Re: St. Lucie Units 1 and 2
Docket Nos. 50-335 and 50-389
Response to NRC Request for Additional Information Related to the Staff's Review of
Severe Accident Mitigation Alternatives for St. Lucie Units 1 and 2

Response to NRC Request for Additional Information Related to the Staff's Review of Severe Accident Mitigation Alternatives for St. Lucie Units 1 and 2

ATTACHMENT 1
RESPONSE TO NRC REQUEST FOR ADDITIONAL INFORMATION TO THE STAFF'S
REVIEW OF THE SEVERE ACCIDENT MANAGEMENT ALTERNATIVES (SAMA)
FOR ST. LUCIE UNITS 1 AND 2

Figure 1-1: Unit 1 Uncertainty Analysis

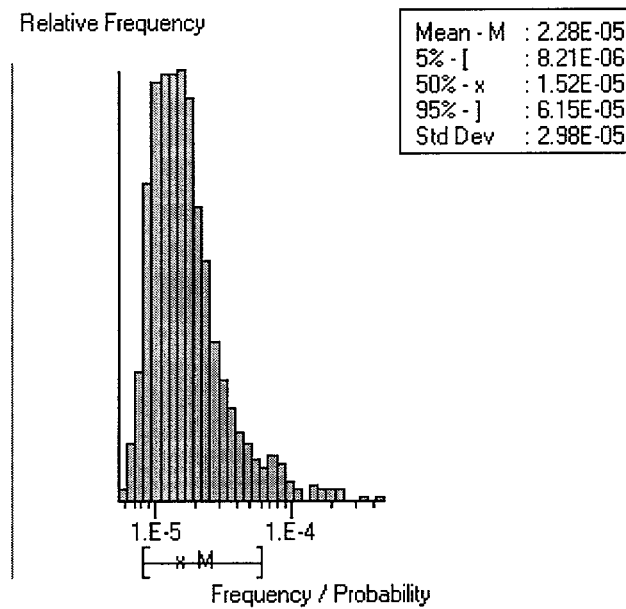
- e. an estimate of the uncertainties associated with the calculated core damage frequency (e.g., the mean and median CDF estimates and the 5th and 95th percentile values of the uncertainty distribution).

As shown in Figure 1-1, the Unit 1 fifth and ninety-fifth percentiles for the SAMA CDF of $2.86\text{E-}05$ are $8.21\text{E-}06$ and $6.15\text{E-}05$, respectively, around a mean value of $2.28\text{E-}05$. The Unit 1 SAMA CDF corresponds to the eighty-fourth (84^{th}) percentile of the distribution.
